Your Ref
BN/24/18/HH
Our Ref
PLAN-024074
Date
30/08/2018

Proposal: First floor extension over garage, porch extension to front elevation to replace existing and single storey rear extension to replace existing.
Site: Sunray, Highground Lane, Barnham, PO22 0BS.
BN/24/18/HH

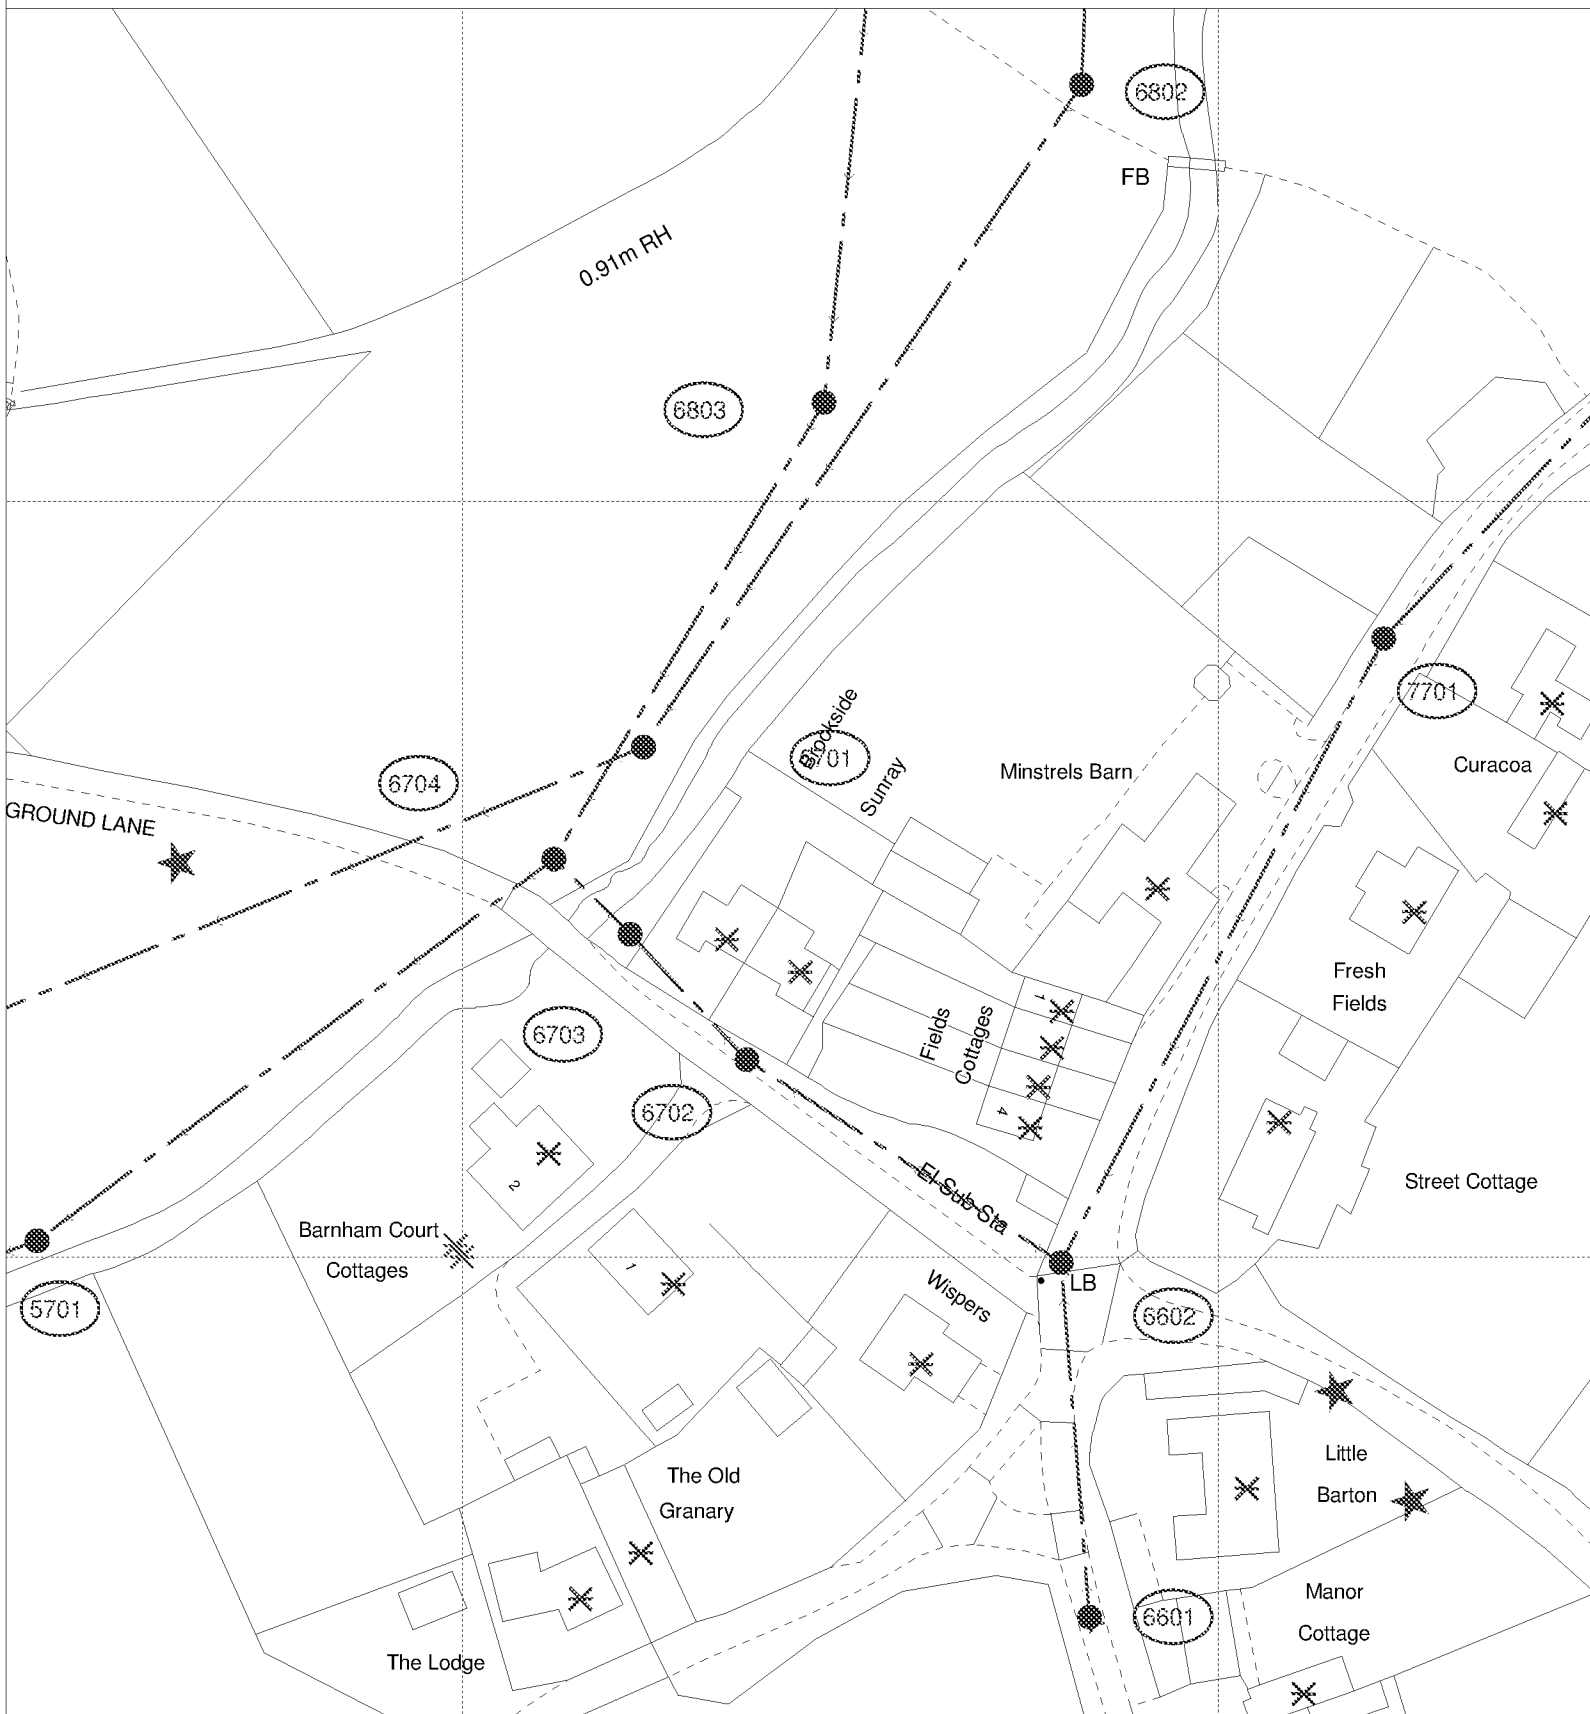
Due to surface water inundation issues in the Lidsey Catchment “The applicant is advised to adopt, where appropriate, the measures in the table “Practical measures to reduce the potential impacts of development”.

Developer should look to protect the public sewerage system from inundation and infiltration, which contribute to flooding in unfavourable conditions.
